Access Compliance Report

Public Rights-of-Way

(Curb Ramps)

Intersection ID: 20571	Main Street: CAMERON_VALLEY_PY	Cross Street: FAIRVIEW_RD	Location: SW
ADA ID: 3878F739C72B	Ramp Type: PerpDiag	Initial Pass/Fail: Fail	Overall Compliance: No
		Severity Score: 12.5

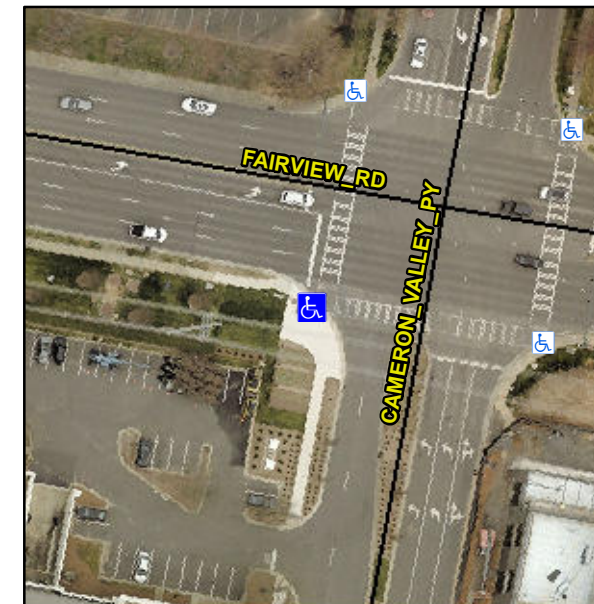
Not Found, R304.2.2

Compliance	Description	Data	Compliance	Description	Data
N/A	Ramp Length (in)	59.5	No	Ramp Slope (%)	8.7
Yes	Ramp Width (in)	51.0	Yes	Ramp XSlope (%)	2.0
N/A	Flare Type LT	N/A	N/A	Flare Type RT	N/A
N/A	Flare Slope LT (%)	N/A	N/A	Flare Slope RT (%)	N/A
N/A	Flare Traversable LT?	N/A	N/A	Flare Traversable RT?	N/A
N/A	Landing Length (in)	N/A	N/A	DWS Provided?	N/A
N/A	Landing Width (in)	N/A	N/A	DWS Contrast?	N/A
N/A	Landing Slope (%)	N/A	N/A	DWS Length (in)	N/A
N/A	Landing X Slope (%)	N/A	N/A	DWS Full Width?	N/A
N/A	Landing Curb? (Y/N)	N/A	N/A	DWS Offset (in)	N/A
N/A	Shared Landing?	N/A			
N/A	Gutter Ponding?	N/A	N/A	Gutter Slope (%)	N/A
N/A	Gutter Lip Ht (in)	N/A	N/A	Gutter X Slope (%)	N/A
N/A	Painted X Walk1?	Yes	N/A	Painted X Walk2?	Yes
	X Walk 1 Direction	To SE		X Walk 2 Direction	To NE
N/A	X Walk 1 Width (in)	103.0	N/A	X Walk 2 Width (in)	105.0
	X Walk 1 Slope (%)	2.1		X Walk 2 Slope (%)	0.5
	X Walk 1 X Slope (%)	0.0		X Walk 2 X Slope (%)	3.4

Remove & Replace Curb Ramp With Two New Directional Ramps or Equivalent.
